Andrea T-VK12, BT-VK12, Ch. VK12

These models appear on pages 2-9, 10 through 2-37 of Rider's TV Manual Volume 2. The following corrections should be made on the schematic diagram.

Belmont 7DX21, Series B

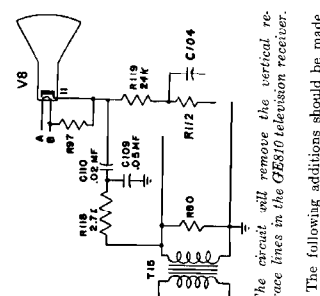
Bias is added to the converter grid of the GE 810 and 814 in the manner shown.

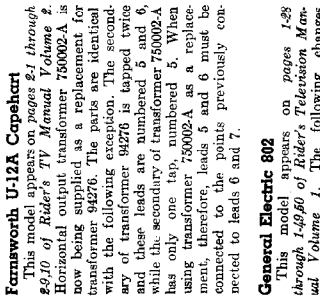
The circuit will remove the vertical retrace lines in the GE810 television receiver.

Fig. 1. The 6AL5 double-diode tube has been added to give automatic frequency control.

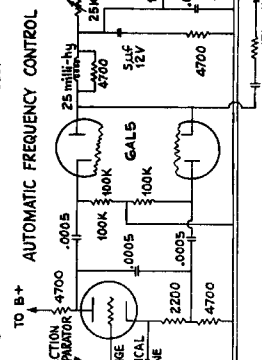
These models appear on pages 1-1 through 1-10 of *Rider's Television Manual Volume 1*. Since the noise levels are quite high in some localities, a/c has been added to minimize disturbances.
 A 6AL5 double-diode tube has been added to develop the oscillator control voltages. This tube receives its signal from the plate of the 6AS7 discharge tube. See Fig. 1 for connection of the 6AL5 into the circuit.

Fig. 2. Changes in wiring output circuit in Philco 48-1001.

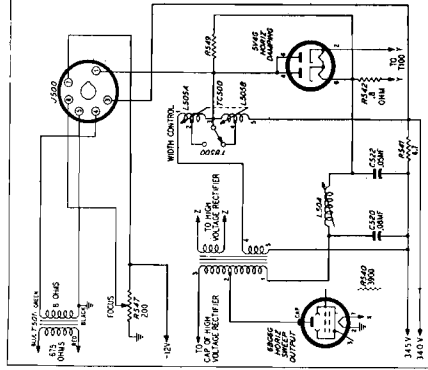
Section 5
See Fig. 2. C509, coupling capacitor, 0.25 μ f, part number 61-0125, was changed to 0.1 μ f, part number 61-0113. The connection of the vertical deflection yoke, P9 and P3, were changed to 4 and 5, respectively. R349, linearity-control limiting resistor, 6,200 ohms, was changed to 33,000 ohms, part number 66-3333340. R545 and R546, horizontal linearity controls No. 2 and No. 3 were removed. The circuit was rewired as shown in Fig. 2.

A 4.5-mc trap has been incorporated into the Sears television chassis 101-846.

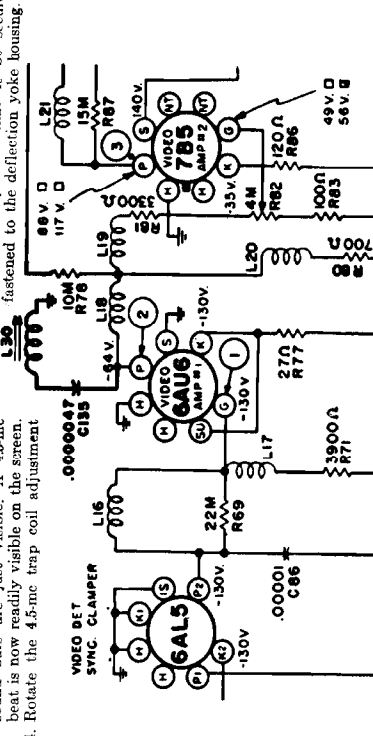
Sears 8133, Ch. 101-846, 101-829-1
This model appears on pages 2-1 through 2-22, 23 of *Rider's TV Manual Volume 2*. Late production of television chassis 101-846 have incorporated a 4.5-mc trap off the plate of the first video amplifier tube 6A16, as shown in the accompanying diagram. This trap is necessary to remove the heterodyne beat caused by the 26- μ m picture if signal at the video receiver being against the very low, but still present, 21.9-mc sound i-f signal. This sound i-f signal tends to pass through the sound traps when the receiver is slightly detuned. This beat will show up on the picture tube as sound bars or a small herringbone pattern across the entire screen.

To install this 4.5-mc trap, proceed as follows:

- Place the chassis on the bench in an upside down position.
- Remove the #6 machine screw located midway between the first video amplifier 6A16 tube socket and capacitors C109 and C110.
- Install the trap coil (L30) on the chassis by placing the screw through the hole in the coil bracket and replacing the screw in the chassis. Before tightening the screw, rotate the trap coil so that the side with the soldering lugs faces the front of the chassis.
- Tighten the machine screw.
- Solder a wire from the coil lug nearest the chassis to ground.
- Connect a 4.7- μ f ceramic capacitor to the top lug on the trap coil and the plate (pin 2) of the 6A16 first video amplifier.
